Horsham
District
Council

HORSHAM DISTRICT COUNCIL CONSULTATION

TO:	Horsham District Council – Planning Dept
LOCATION:	Phases 2 and 3 Land at Wellcross Farm Broadbridge Heath
DESCRIPTION:	Application for Approval of Details Reserved by Condition 2 (Construction Management Plan), ³ (borehole to meet Private Water Supplies), ⁴ (Private Water Supply Management Plan), ⁵ (finished floor levels and external ground levels) and 7 (underground services) to approved application DC/24/0205 Reserved matters application pursuant to condition 5 of outline planning permission DC/19/1897 for the provision of phases 2 and 3 of Land at Wellcross Farm to provide a continuing care retirement community with 94 units of accommodation (C2), with access, infrastructure, open space, landscaping and associated works including an onsite borehole water supply).
REFERENCE:	DISC/26/0012 & DISC/26/0013
RECOMMENDATION:	Advice / Modification / More information.
2nd response in Red	Advice / Modification / More information.

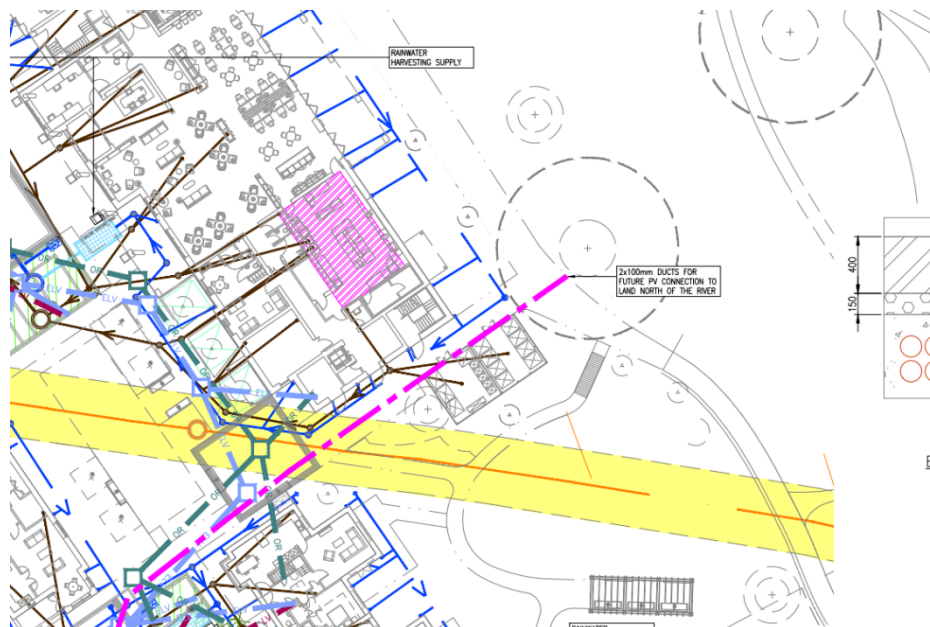
The RPA, of the unknown tree shown in the image above, taken from Electrical & Electrical Services Drawing No. 1163-ESD-XX-00-DR-XX-P2-1001, revision 2, still indicates that the ducts for the future PV connection to land north of the river fall within the tree's RPA. Please seek confirmation that the ducts will be removed and that the PV connection will not be sited within the RPA, or alternatively that trenchless installation methods will be used at a depth greater than 1.5 m below existing ground levels. Concerns addressed.

Accordingly, amendments should be sought to the route of the service runs to ensure that they do not encroach within the RPA of tree T31, and outside of the RPA, of the unknown tree in the above image taken from Electrical & Electrical Services Drawing No. 1163-ESD-XX-00-DR-XX-P2-1001. [Concerns addressed.](#)

One potential solution would be to relocate the service runs further north, outside the RPA of T31, and outside of the RPA, of the unknown tree in the above image. If this is not considered feasible, trenchless installation methods should be employed, such as thrust boring or impact moling.

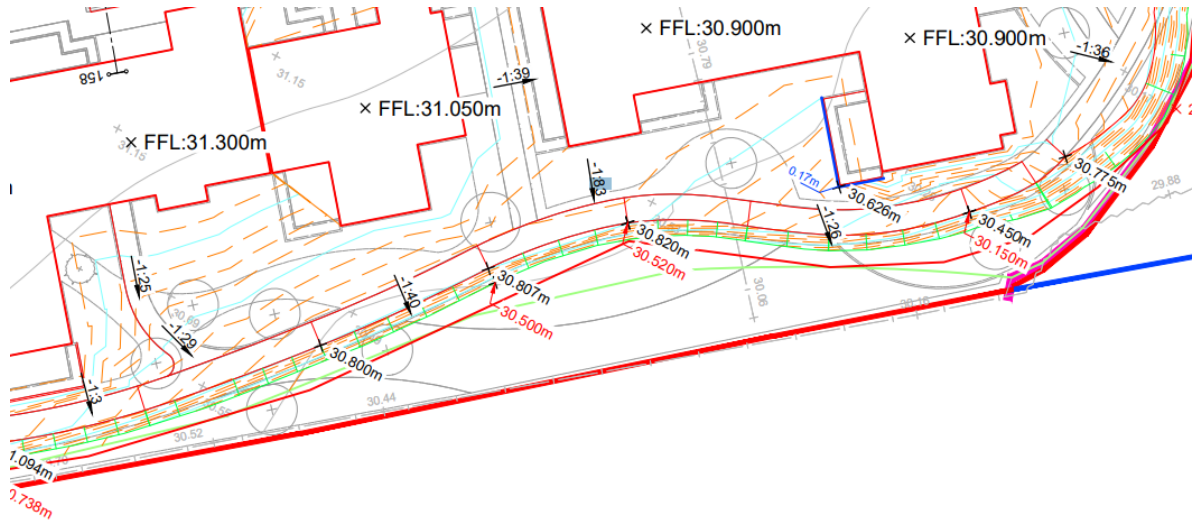
Further concerns are also raised in relation to the proposed landscaping works and associated land level changes in the area to the northwest of off-site trees T30 and T31, both oaks. Given the lack of detail on how the works would be completed without resulting in direct construction damage or indirect post-development harm, including root damage and soil compaction, these proposals are considered problematic. Please seek confirmation on the exact extent of the level changes and landscaping works within the RPA of T30, and T31. [Concerns addressed.](#)
